ADDENDUM NO. 8

Reference: Holland Centennial Commons
Dixie State College – St. George, Utah
DFCM Project No. 06297640

ADDENDUM #8

PROJECT:	**Dixie State College of Utah** **Holland Centennial Commons**	**ARCHITECT'S PROJECT NO:**	09625
		No. Pages:	38 pages
OWNER:	Dixie State College	**DATE:**	January 6, 2011
ARCHITECT:	VCBO Architecture	**GENERAL CONTRACTOR:**	
SUBMITTAL DATE:	January 19, 2011	**SUBMITTAL TIME:**	12:00pm

A1 LEVEL 02M LIGHTING PLAN

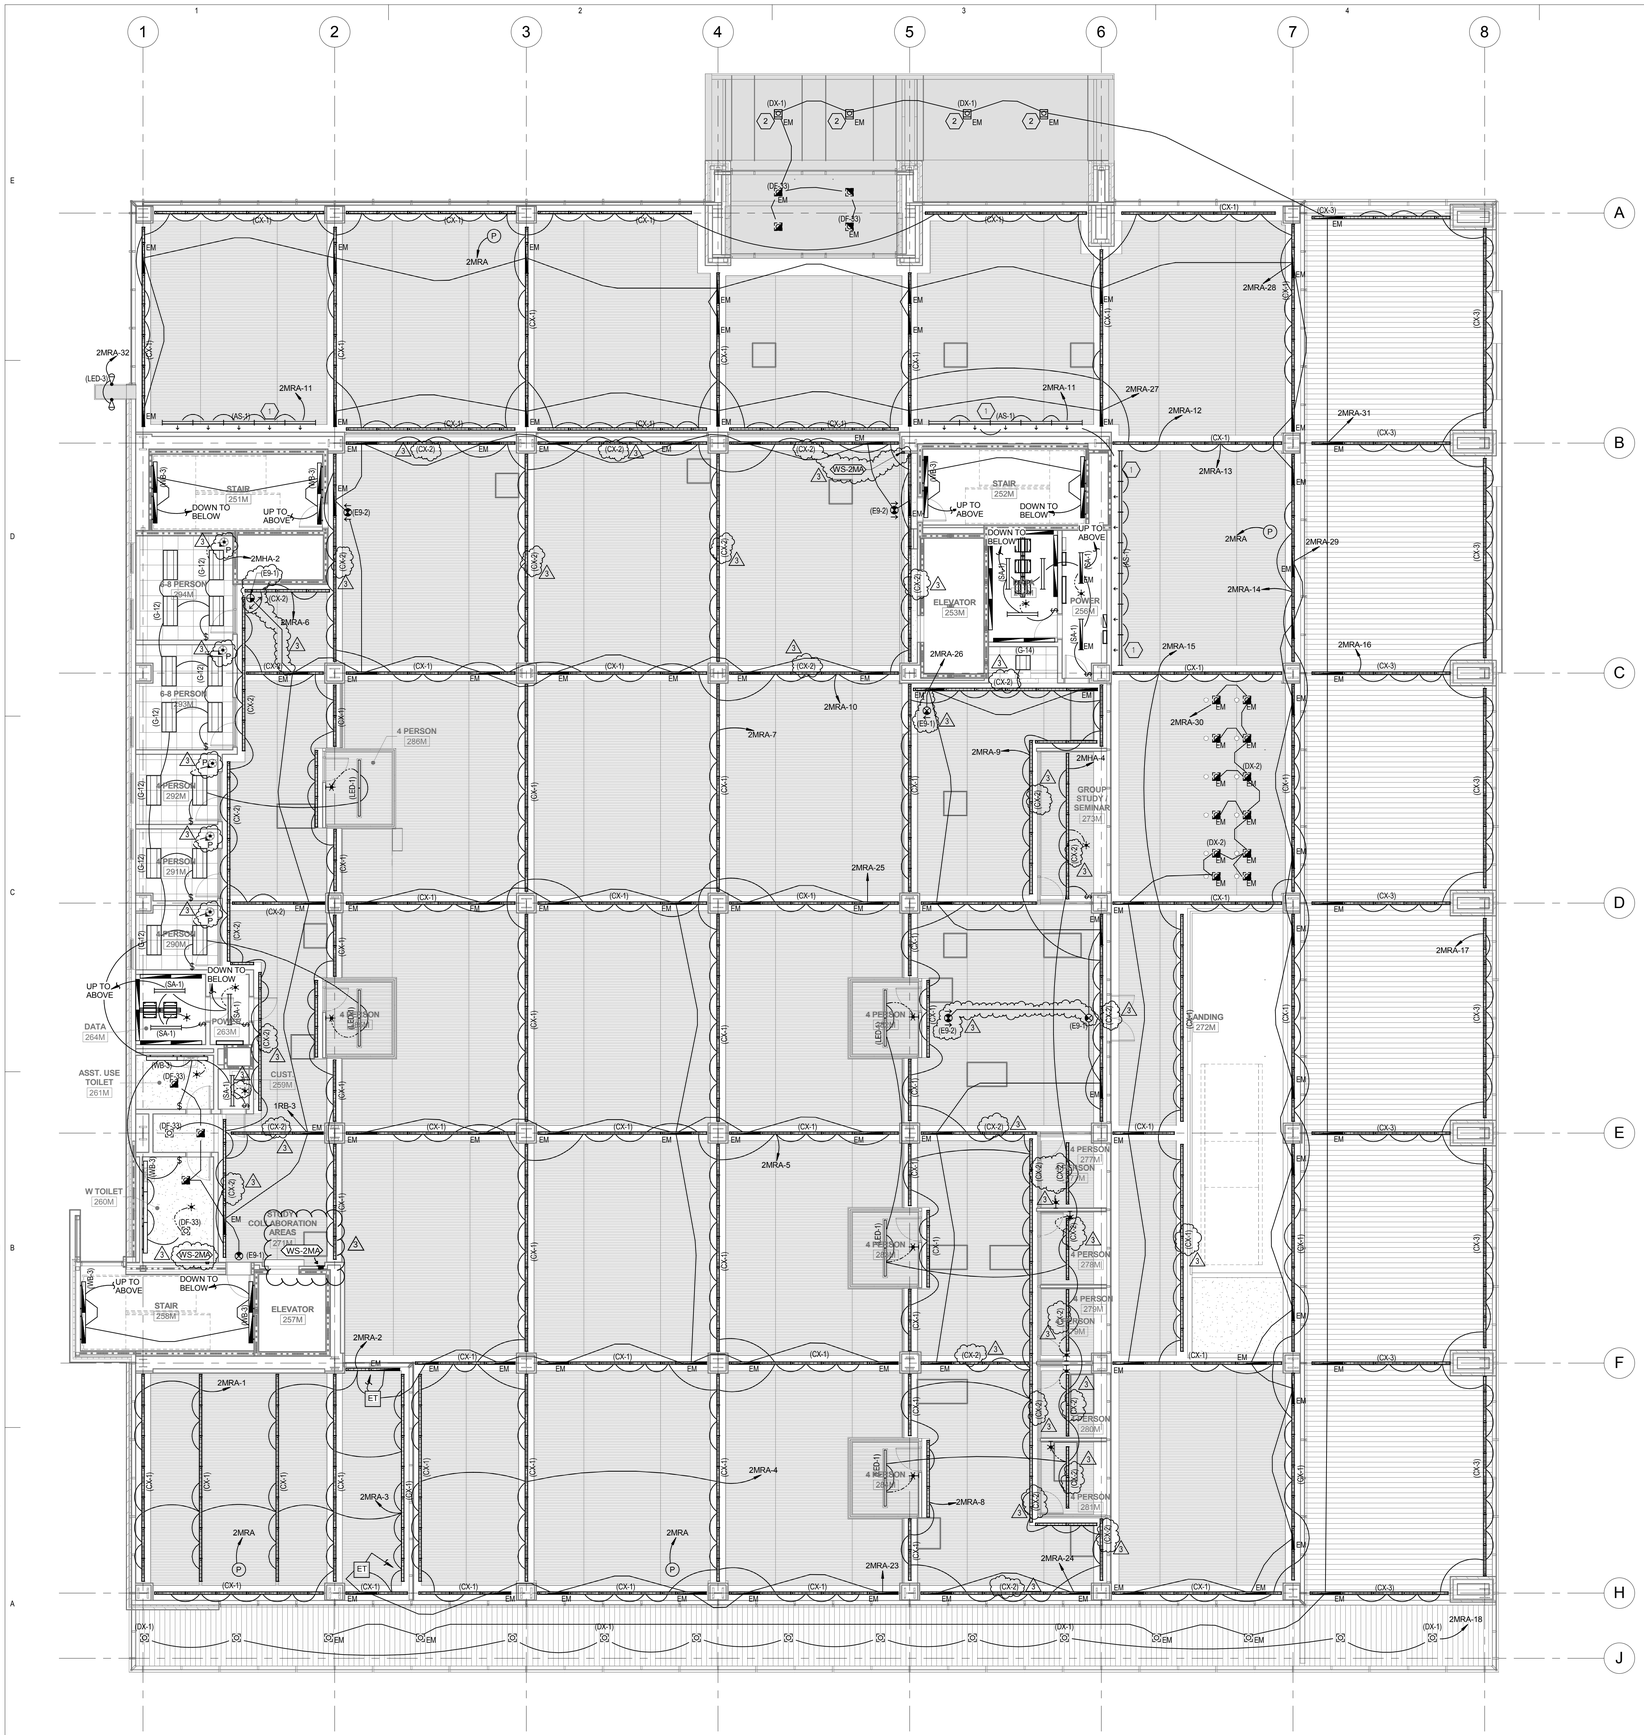
1. Refer to attached full size sheet EL102M for changes described below.
2. Relay override wall stations WS-2MA have been added near grids B-5 and E.5-2.
3. Text identifiers for photo-responsive occupancy sensors have been turned on. All enclosed spaces with an exterior window shall have photo-responsive occupancy sensors.
4. Fixture type identifier text has been turned on for fixtures between grids B and H and grids 1.5 and 6.5.
5. Add an occupancy sensor in Custodian 259M.
6. Add an E9-1 exit sign near grids B.6 and 1.5.

EL103
Sheet Number

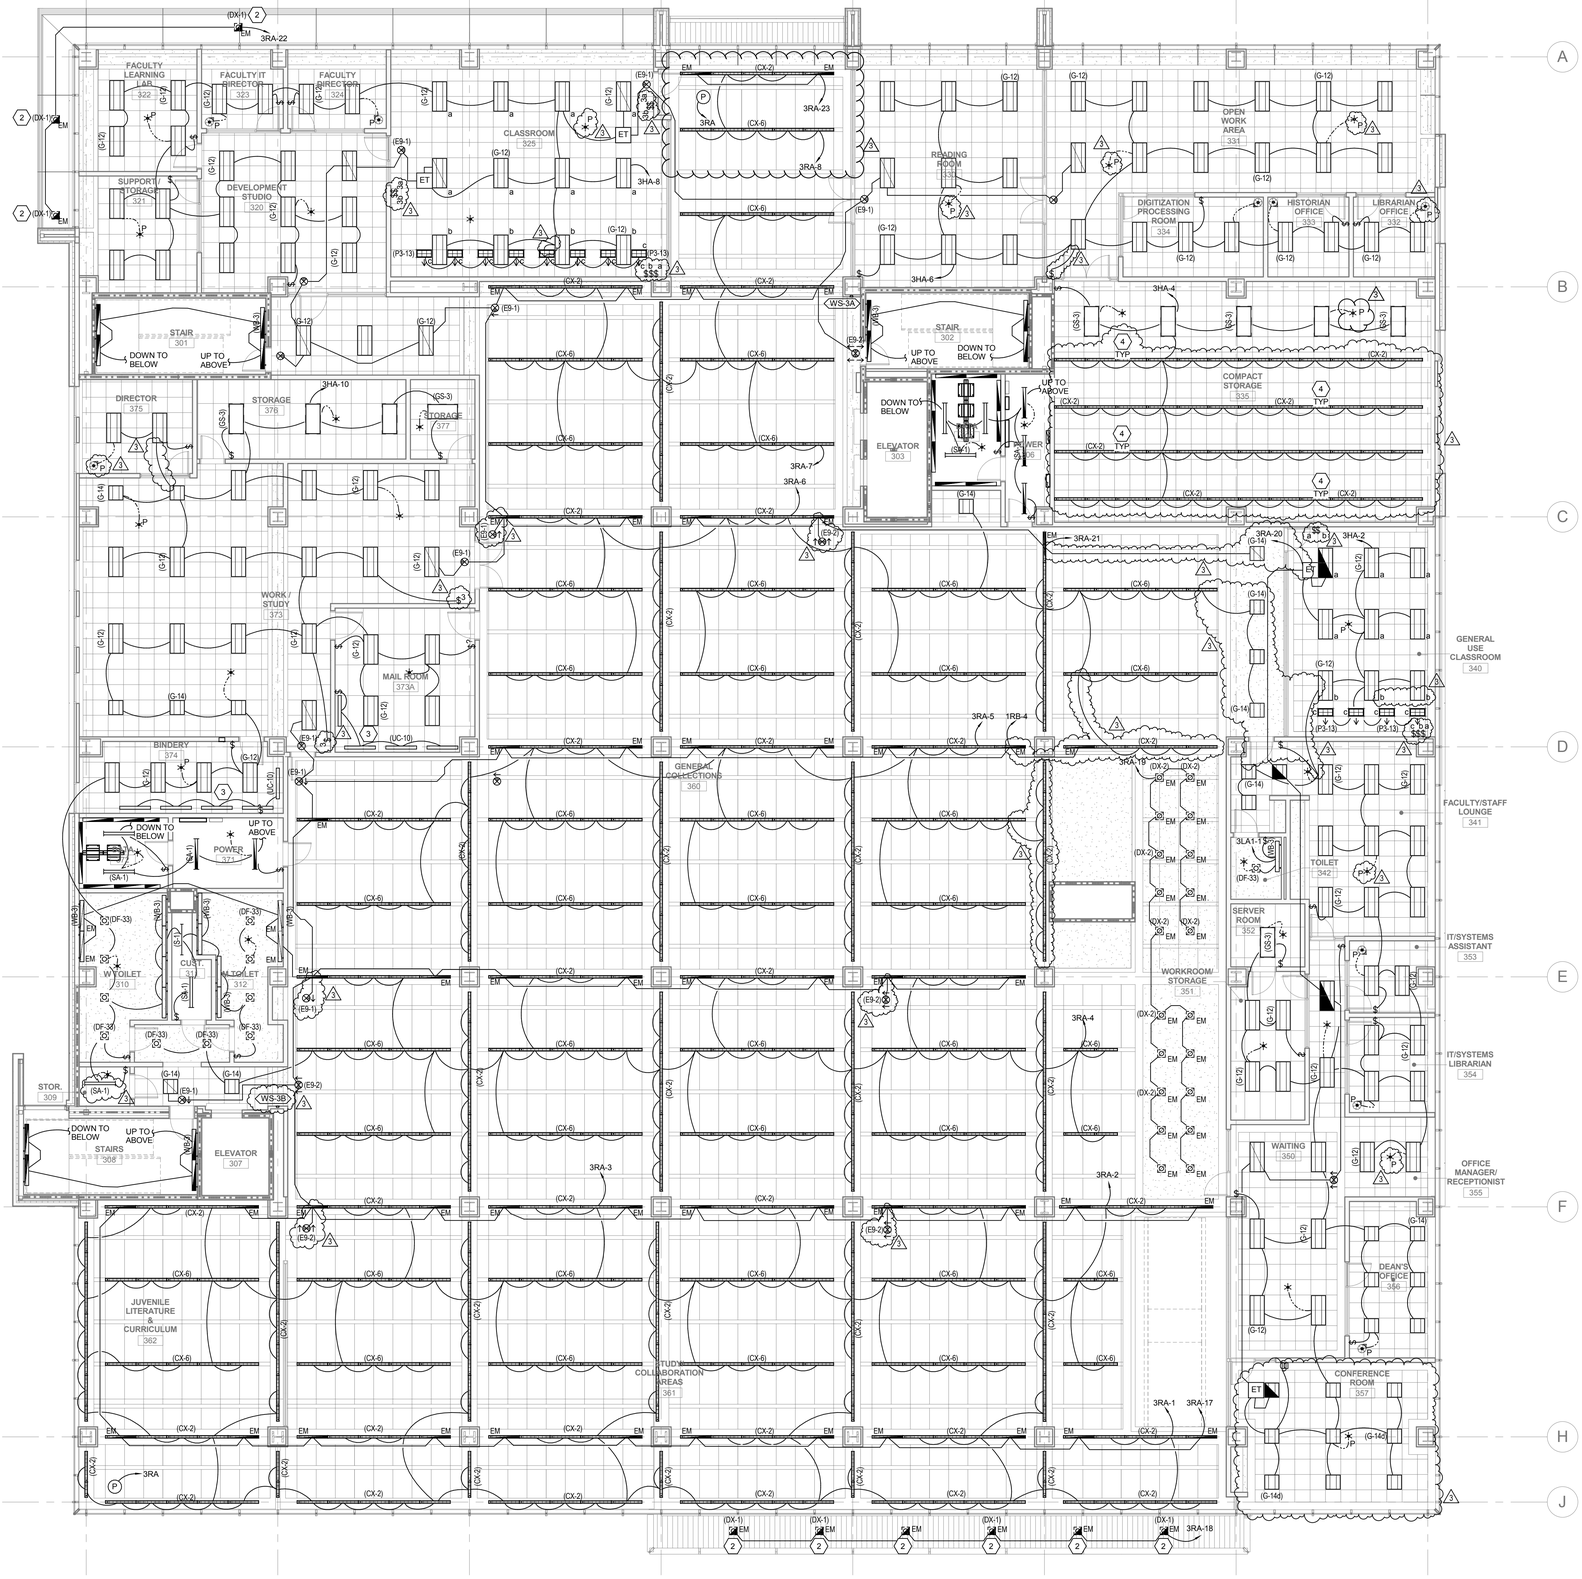
1. Refer to attached full size sheet EL103 for changes described below.
2. Text identifiers for photo-responsive occupancy sensors have been turned on. All enclosed spaces with an exterior window shall have photo-responsive occupancy sensors.

A1 LEVEL 04 LIGHTING PLAN

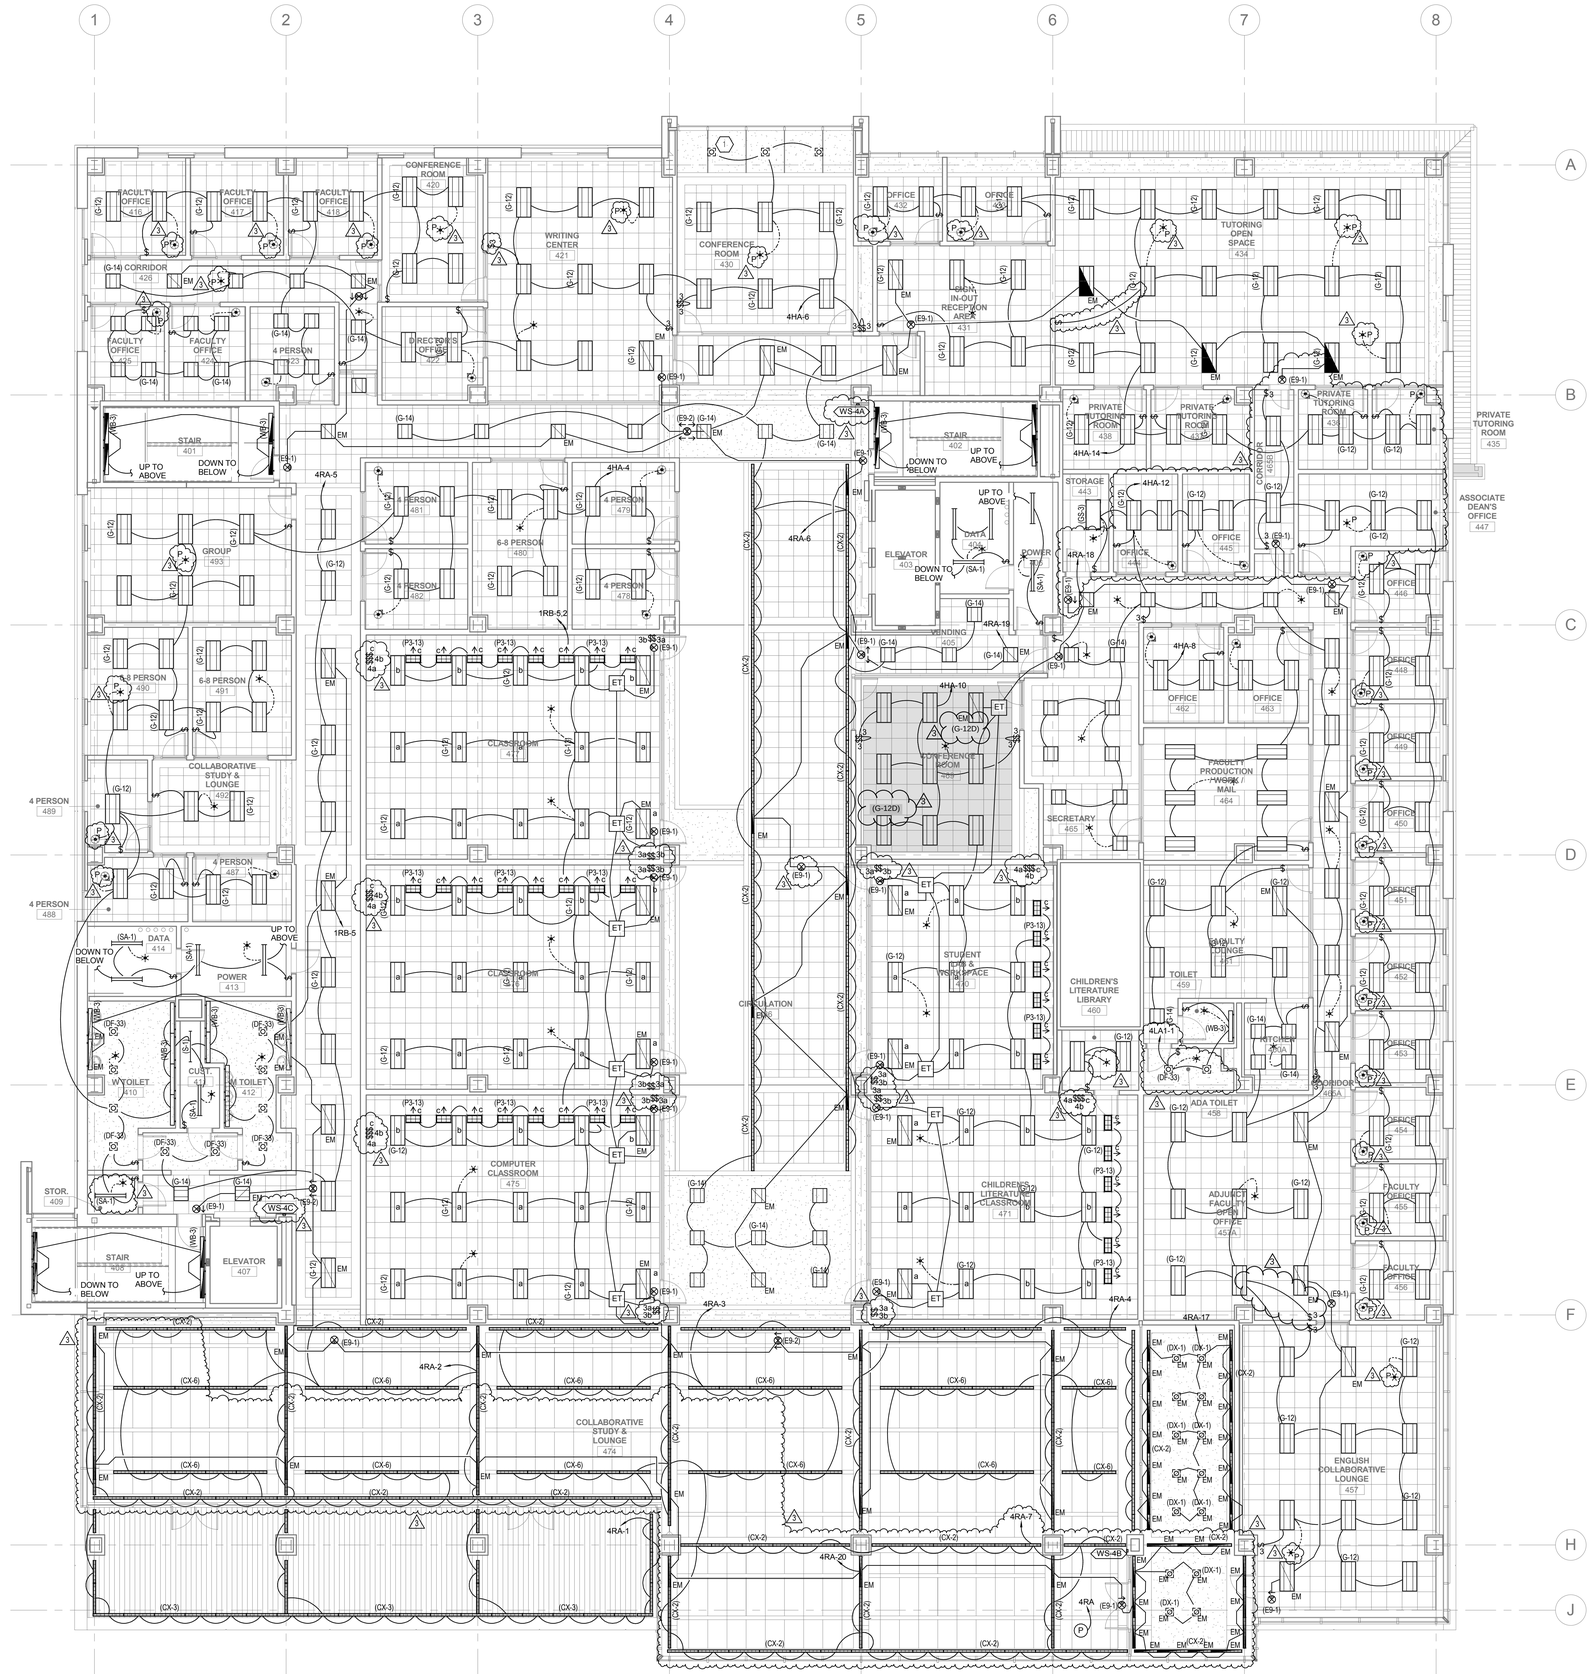
1. Refer to attached full size sheet EL104 for changes described below.
2. Relay override wall station identifier text for WS-4A, WS-4B and WS-4C has been turned on.

A1 LEVEL 05 LIGHTING PLAN

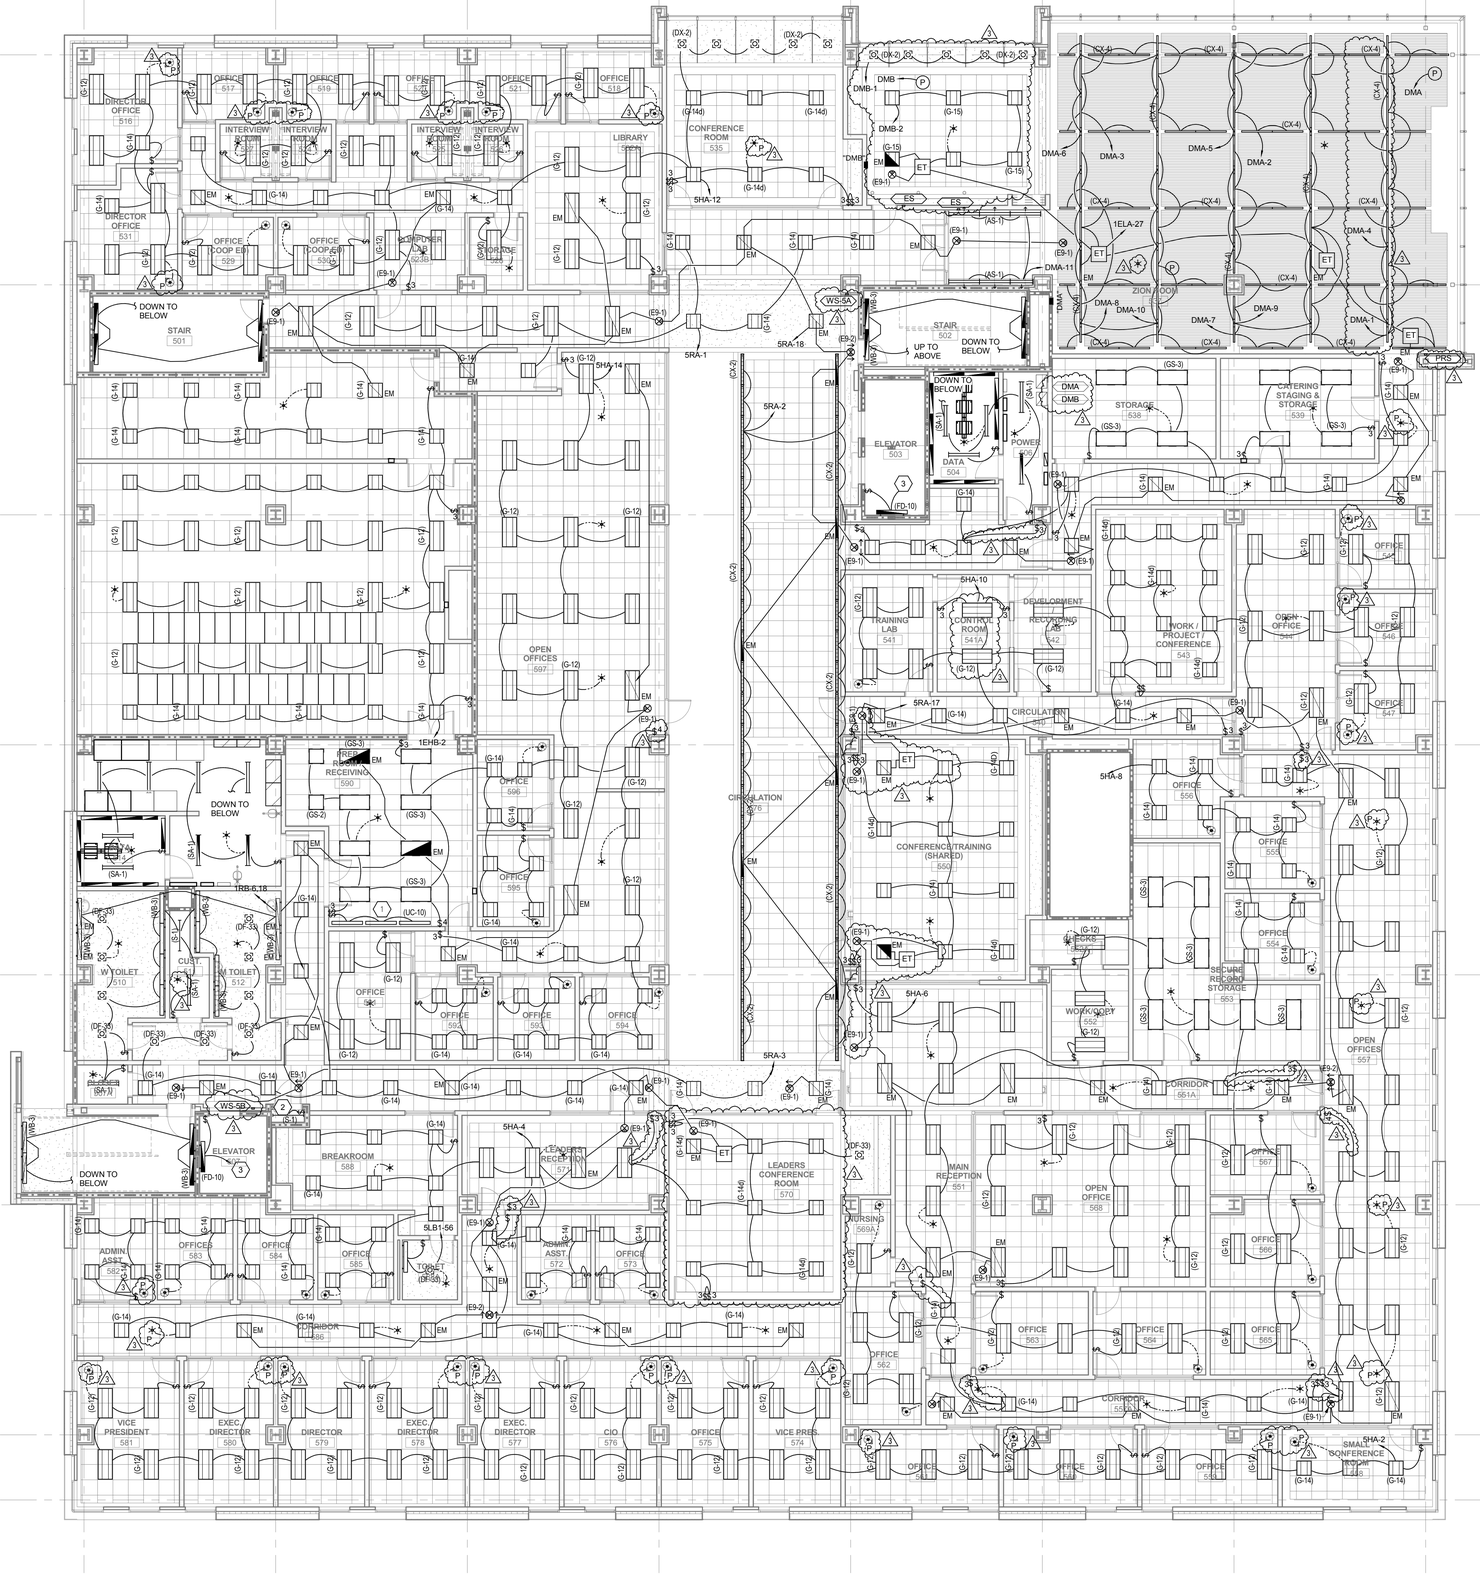
1. Refer to attached full size sheet EL105 for changes described below.
2. Relay override wall station identifier text for WS-5A and WS-5B has been turned on.
3. Dimming entry station and preset station identifier text for ES and PRS has been turned on.
4. Text identifiers for photo-responsive occupancy sensors have been turned on. All enclosed spaces with an exterior window shall have photo-responsive occupancy sensors.
5. Fixtures in Conference 543 are type G-14D.
6. Change fixtures in Control Room 541A from GS-3 to G-12.
7. Add racks for dimmers DMA and DMB in electrical room 506.
8. Add a 3-way switch near grids C-6.
9. Add (2) E9-1 exit signs in Conference 550.
